Sunbeam Service Sheet No. 10

Subject: Oil Pressure Switch (S.7 & S.8 models)

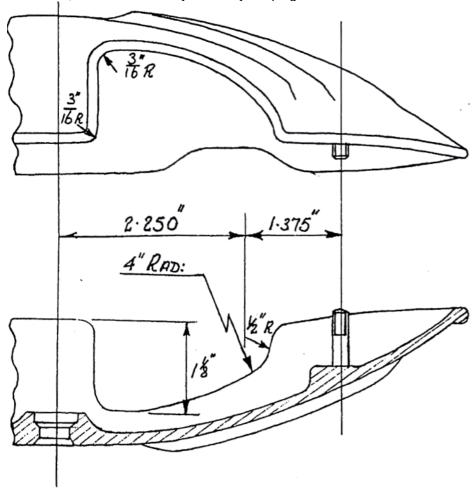
To prevent premature failure of the oil switch, due to overheating, it has now been modified and an extension piece utilised which projects the switch into the cooling air stream.

On these models fitted with a switch direct on the head or with a plain plug fitted in place of the switch, the new extension should be fitted so that the switch is at the lowest position.

In addition, it will be necessary to modify the plug cover in accordance with the drawing below.
